# PLANNING APPLICATION FOR THE EXPANSION OF A MATERIALS RECOVERY FACILITY AT CAPPOGUE AND DUNSINK, BALLYCOOLIN ROAD, DUBLIN 11.

## Response to Request for Further Information

**Abstract:** This report contains the response to a Request for Further Information (RFI) in connection with planning case number ABP-315257-22 for development at Cappogue and Dunsink, Dublin 11.

Scale 1:50

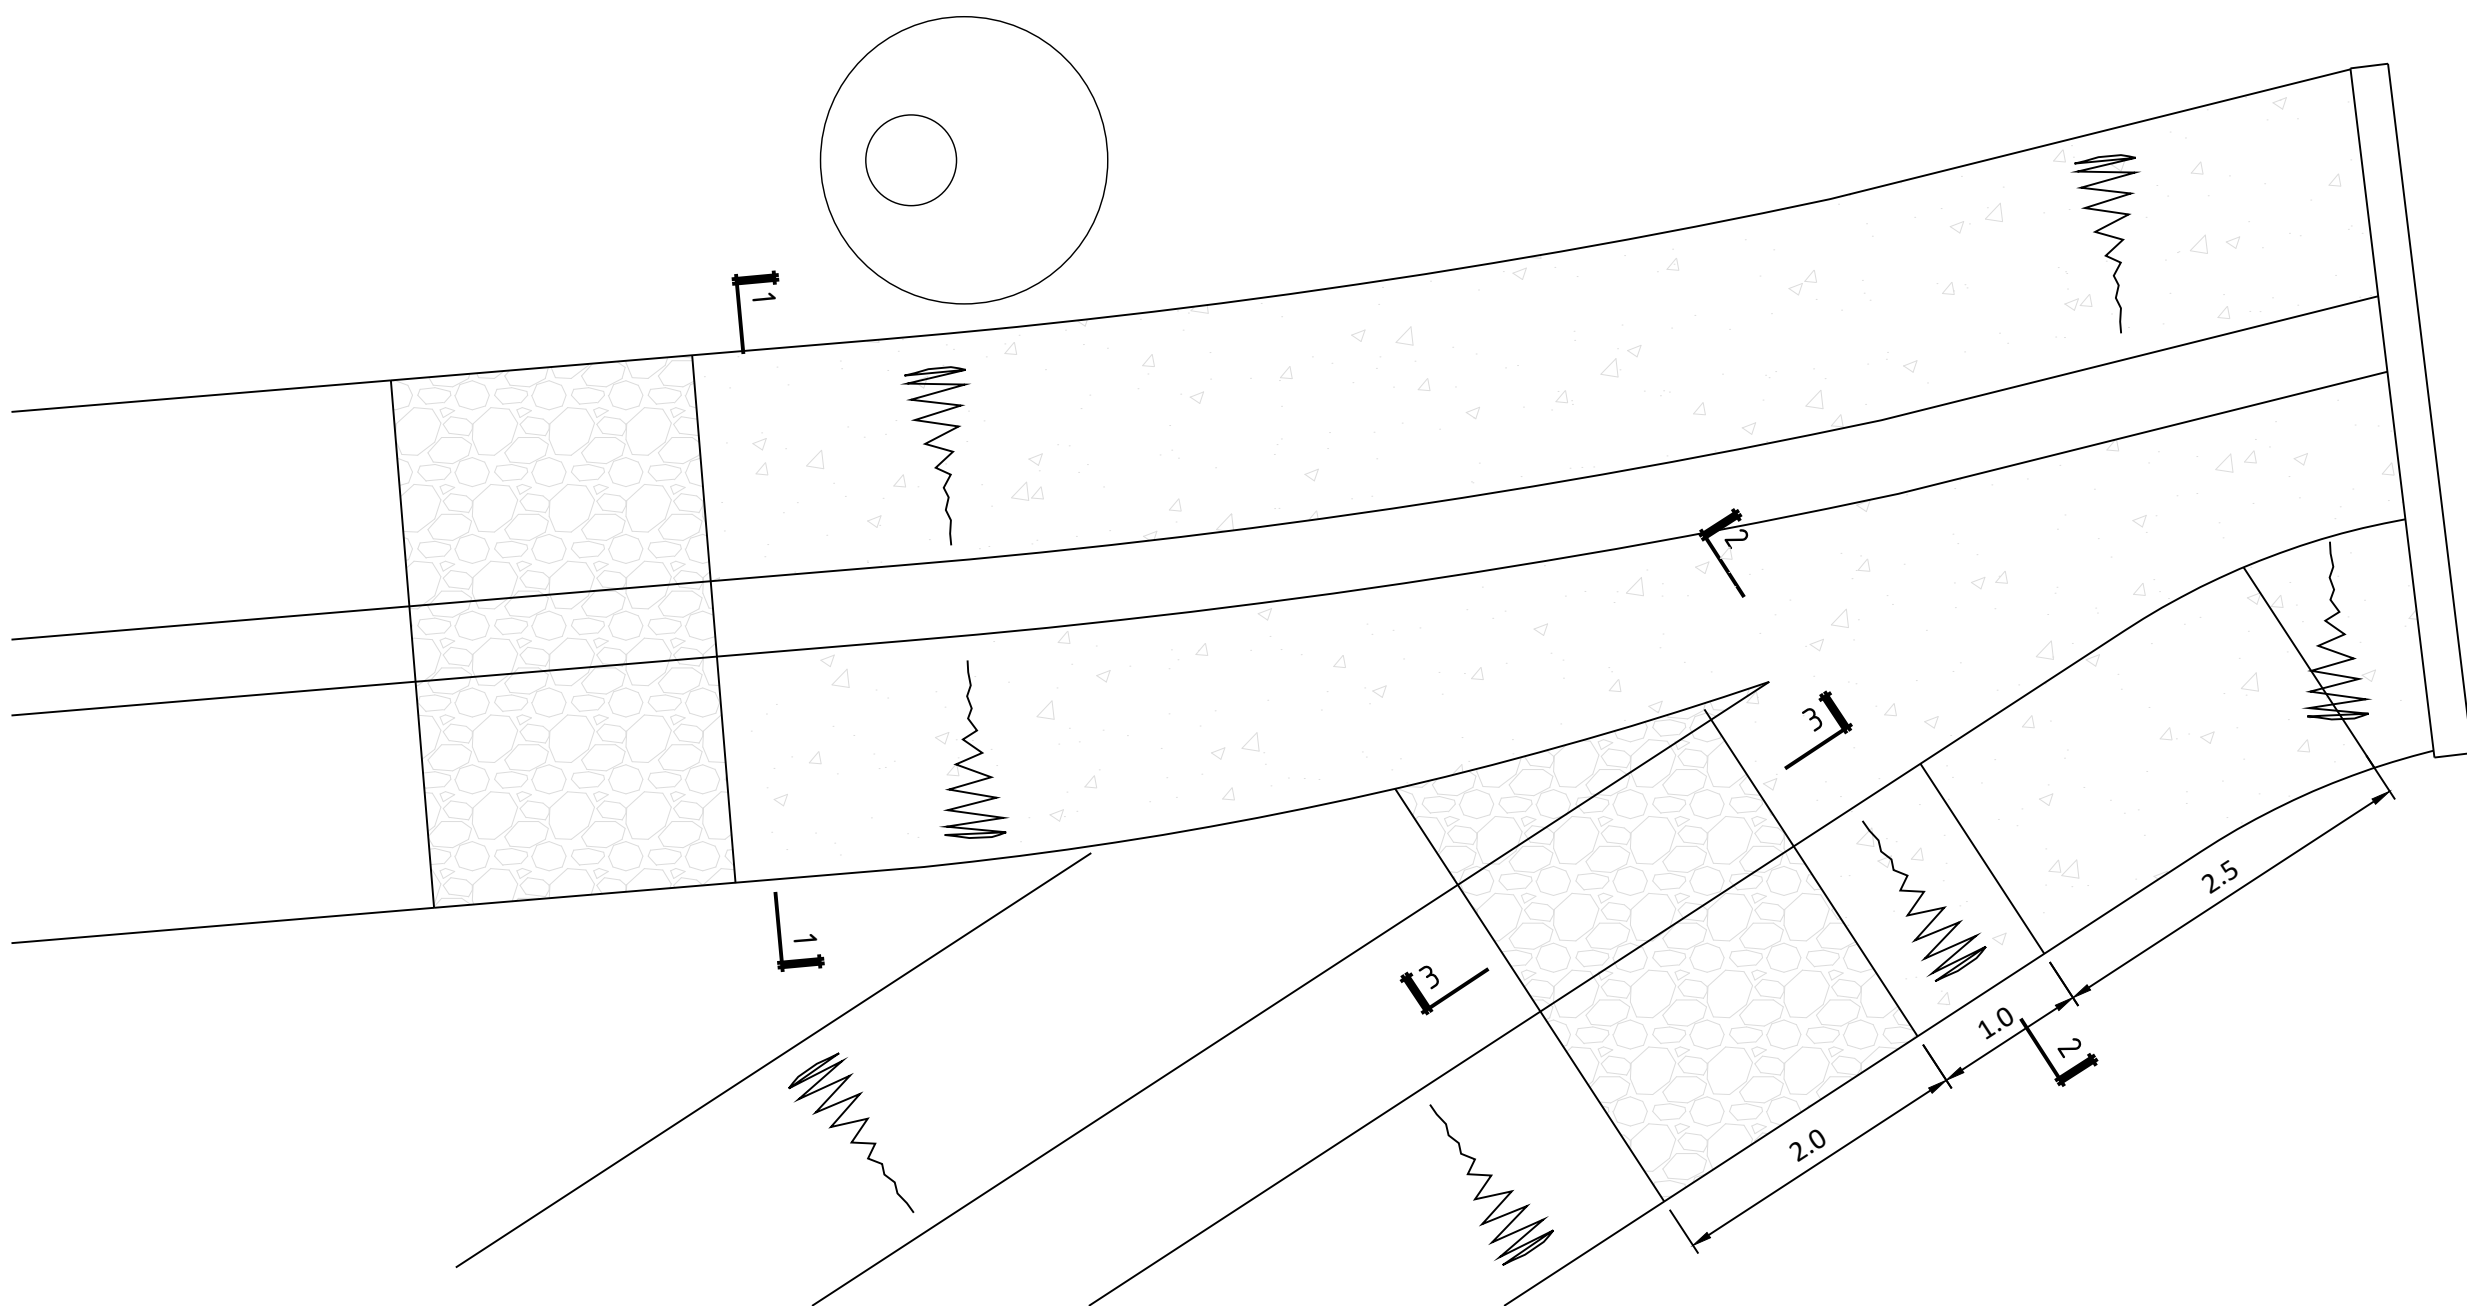
On 06/10/2023 TII Land Use Planning issued a letter response via email and is included in Appendix 3. TII requested clarification in regard to the structural condition of the M50 culvert, the potential impact of the concrete lining and the potential impact of any exceedance flow on the culvert.

- Protect the inlet works during construction.
- Facilitate future access as required to unblock the trash rack.
- Provide scour protection at the interfaces between lined and unlined channel sections. See Figure 2 and Drawing P21-150-0700-0011 RevB Proposed M50 Culvert Inlet Details details 1 and 2 in the enclosed.
